APPLICATION NO.	FILING DATE	FIRST NAMED INVENTOR	ATTORNEY DOCKET NO.	CONFIRMATION NO.
10/589,153	08/11/2006	Martinus Cornelus van den Aker	BEILER2	6683
6980 7590 08/19/2010 TROUTMAN SANDERS LLP		EXAMINER		
5200 BANK OF AMERICA PLAZA 600 PEACHTREE STREET, N.E. SUITE 5200 ATLANTA, GA 30308-2216			MORRISON, THOMAS A	
			ART UNIT	PAPER NUMBER
			3653	
			NOTIFICATION DATE	DELIVERY MODE
			08/19/2010	ELECTRONIC

Application No.	Applicant(s)			
Office Action Summary	10/589,153	VAN DEN AKER, MARTINUS CORNELUS			
omoo nodon odininaly	Examiner	Art Unit			
	THOMAS A. MORRISON	3653			
The MAILING DATE of this communication appears on the cover sheet with the correspondence address Period for Reply					
A SHORTENED STATUTORY PERIOD FOR REPLY IS SET TO EXPIRE 3 MONTH(S) OR THIRTY (30) DAYS, WHICHEVER IS LONGER, FROM THE MAILING DATE OF THIS COMMUNICATION.  - Extensions of time may be available under the provisions of 37 CFR 1.136(a). In no event, however, may a reply be timely filed after SIX (6) MONTHS from the mailing date of this communication.  - If NO period for reply is specified above, the maximum statutory period will apply and will expire SIX (6) MONTHS from the mailing date of this co

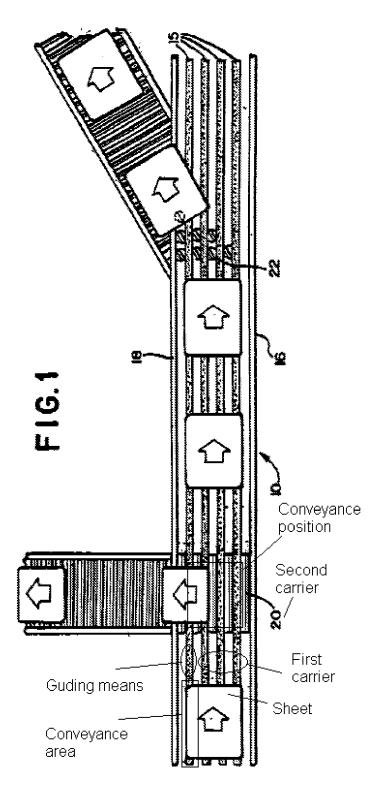
moving the sheet (unnumbered sheet in annotated Fig. 1 below) in a first direction by applying a first carrier (first carrier in annotated Fig. 1 below) which is movable in the first direction and which is capable of retaining the sheet by means of a

surface force (e.g., friction), wherein a retainer area (area retained by first carrier in annotated Fig. 1 below) of the sheet is retained by the first carrier (first carrier in annotated Fig. 1 below) and a conveyance area (conveyance area in annotated Fig. 1 below) of the sheet projects with respect to the first carrier (first carrier in annotated Fig. 1 below);

conveying the sheet from the first carrier (first carrier in annotated Fig. 1 below) to a second carrier (second carrier in annotated Fig. 1 below) which is movable in a second direction and which is capable of retaining the sheet by means of a surface force (e.g., friction), wherein the sheet is put in a conveyance position (conveyance position in annotated Fig. 1 below) by the first carrier (first carrier in annotated Fig. 1 below), in which position the complete conveyance area overlaps the second carrier (second carrier in annotated Fig. 1 below); and

moving the sheet in the second direction by applying the second carrier (second carrier in annotated Fig. 1 below); wherein, continuously during the movement of the sheet in the first direction through to the conveyance position (conveyance position in annotated Fig. 1 below), guidance of a guidance area (area of sheet contacted by guiding means in annotated Fig. 1 below) of the sheet, which comprises at least a portion of the conveyance area (conveyance area in annotated Fig. 1 below) of the sheet, takes place by applying guiding means (guiding means in annotated Fig. 1 below), which guidance is cancelled only when the sheet has reached the conveyance position (conveyance position in annotated Fig. 1 below). As shown in annotated Fig. 1 below, the "first carrier" includes the three right-most belts (15, 15 and 15) and

the "guiding means" includes the one left-most belt (15). The retainer area is the area supported across the width of the first carrier. The conveyance area is the area of the sheet that projects to the left of the width of the first carrier. The guidance area is the area of the sheet that is supported across the width of the guiding means.

Regarding claim 26, Figs. 1-16b of Baker disclose that the guiding means (guiding means in annotated Fig. 1 below) are adapted to guaranteeing that the guidance area of the sheet and the retainer area of the sheet extend at a substantially equal level.

Regarding claim 27, Figs. 1-16b of Baker disclose that the guiding means (guiding means in annotated Fig. 1 below) are movable in the first direction.

Regarding claim 28, Figs. 1-16b of Baker disclose that, during the time that guidance of the guidance area of the sheet takes place, a speed at which the guiding means (guiding means in annotated Fig. 1 below) are moved is substantially equal to a speed at which the first carrier (first carrier in annotated Fig. 1 below) is moved.

guiding means (guiding means in annotated Fig. 1 above) for guiding a portion of sheets which are retained by the first carrier (first carrier in annotated Fig. 1 above), as far as in the conveyance region (conveyance position in annotated Fig. 1 above),

wherein the guiding means (guiding means in annotated Fig. 1 above) are movable in the first direction and comprise an endless conveyor belt (left-most conveyor belt in annotated Fig. 1 above), and

wherein the conveyor belt (left-most belt 15 annotated Fig. 1 above) comprises at least two different types of areas (e.g., area of a first segment of the belt, area of a second segment of the belt spaced away from the first segment along the direction that

the belt extends lengthwise, etc.). Any two segments of the belt can be considered two different types of areas of the belt. However, Baker does not explicitly disclose that at the location of one type of area a dimension of the conveyor belt (left-most belt 15 in annotated Fig. 1 above) in a transverse direction (width) is different than at the location of another type of area, as claimed.
